Planning Commission Meeting

Meeting Date: Tuesday, March 19, 2019

5.3. 18-047 DR/VAR/ADJ Sandy Vault Self Storage 41 - 243

SANDY VAULT A SELF STORAGE FACILITY DESIGN REVIEW CHAMPION WAY, SANDY, OREGON 97055

SANDY VAULT
SITE
 SANDY, OREGON 97055

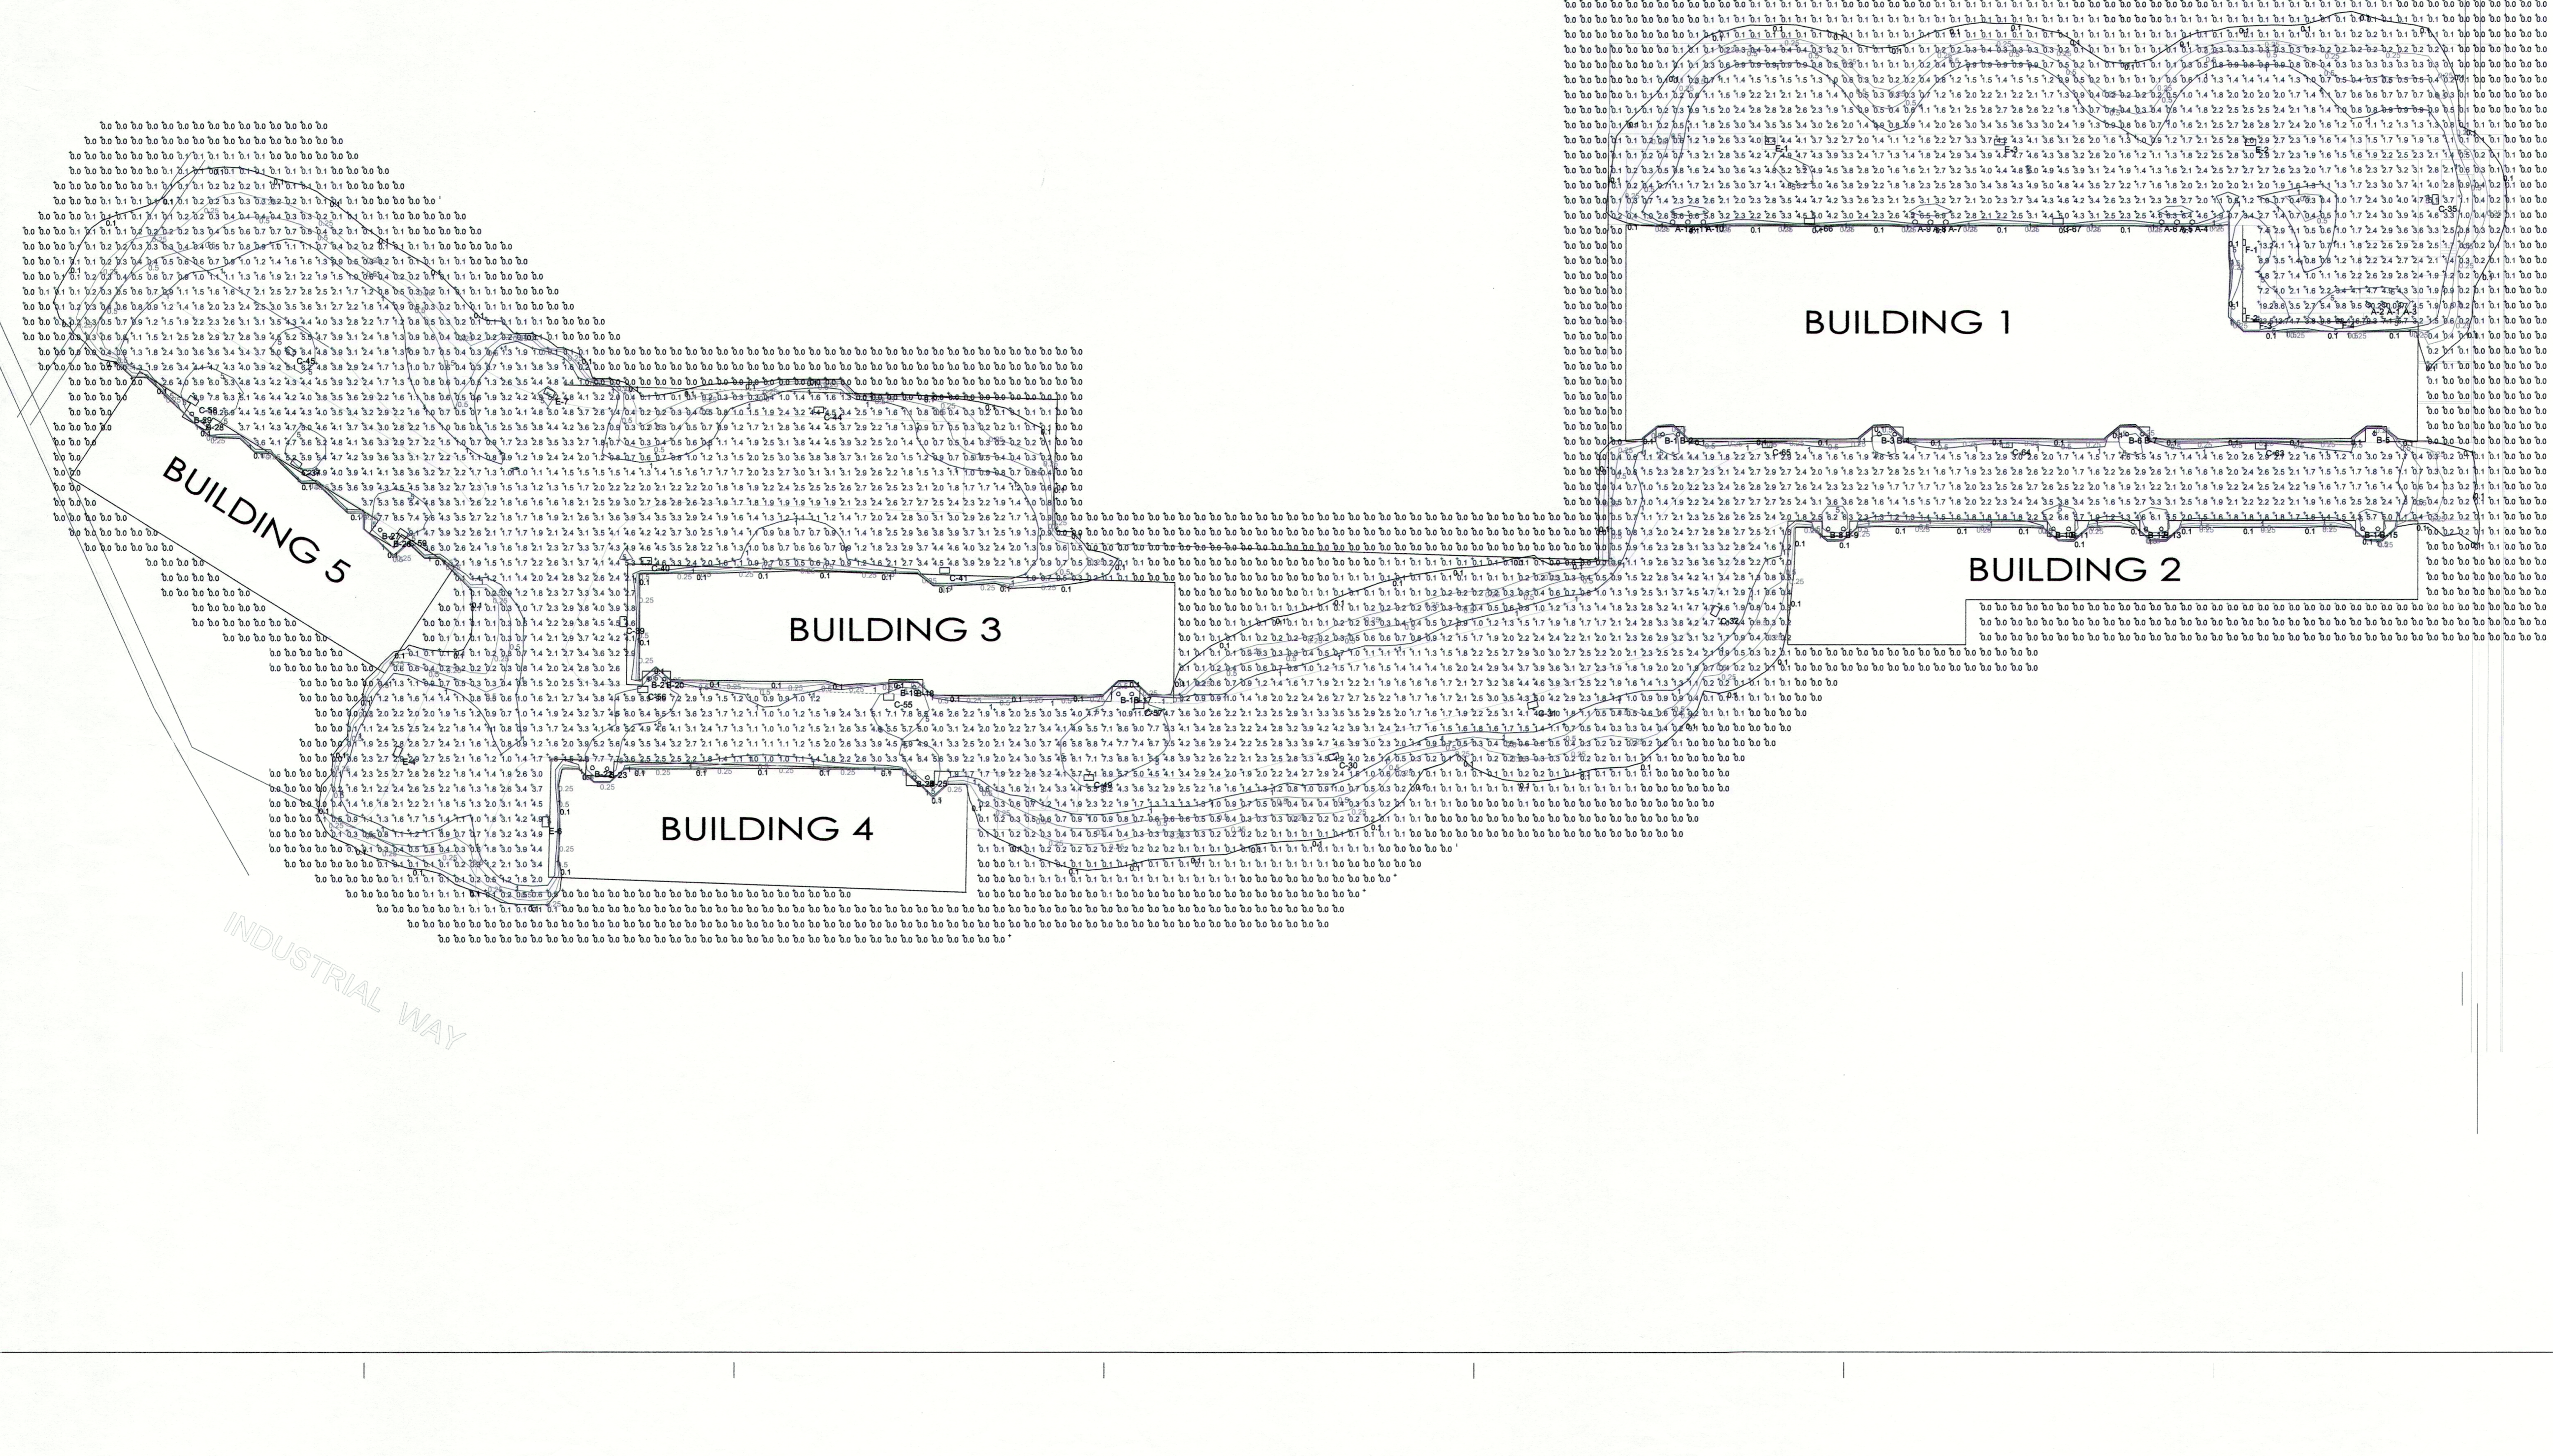
RESPONSE: Section 17.90.120(H.3) specifies that walkways and parking lots should be illuminated at 1.5 – 2.0 foot candles. The submitted Photometric Plan (Exhibit C, Sheet E0.1) details parking lot illumination at 0.3 to 4.7 foot candles and walkway illumination at 0.6 to 19.2 foot candles. The applicant is proposing multiple different types of lights. **The applicant shall update the proposed parking area lights with lights that have a smaller distribution and emit less intense light and shall add pedestrian scale lighting along the walkways such that they are illuminated at 1.5 – 2.0 foot candles.** Lighting is discussed further in Chapter 15.30 (Dark Sky) of this document.

RESPONSE: *The applicant submitted a Photometric Plan (Exhibit C, Sheet E0.1) detailing the location of proposed lighting and projected foot candles. Section 15.30.60(D) requires all lighting systems to be designed so that the area 10 feet beyond the property line receives no more than 0.25 (one quarter) of a foot-candle of light. It is difficult to see the property lines on the submitted Photometric Plan, but it appears that light trespass 10 feet beyond the subject property lines exceeds the 0.25 foot-candle limit in multiple places. **The applicant shall update the Photometric Plan such that illumination 10 feet beyond the property lines in all directions does not exceed 0.25 foot candles. The property lines and foot candles at 10 feet from the property line shall be labeled and legible.***

*Section 17.90.120(H.3) specifies that walkways and parking lots should be illuminated at 1.5 to 2.0 foot candles. The submitted Photometric Plan (Exhibit C, Sheet E0.1) details parking lot illumination at 0.3 to 4.7 foot candles and walkway illumination at 0.6 to 19.2 foot candles. The applicant is proposing multiple different types of lights. **The applicant shall update the proposed parking area lights with lights that have a smaller distribution and emit less intense light and shall add pedestrian scale lighting along the walkways such that they are illuminated at 1.5 – 2.0 foot candles.***

*The Dark Sky ordinance requires that all new lighting be full-cutoff and downward facing. The submitted lighting cut-sheets (Exhibit I) and Photometric Plan (Exhibit C, Sheet E0.1) indicate that multiple proposed lights are 4,000 Kelvins. Based on recommendations from the Audubon Society of Portland and the International Dark-Sky Association, **staff recommends all proposed lighting be full-cutoff and not exceed 3,000 Kelvins. The applicant shall submit updated lighting fixture cut-sheets for all proposed exterior lighting that detail the lighting fixtures as full-cutoff and not exceeding 3,000 Kelvins to minimize negative impact on wildlife and human health.***
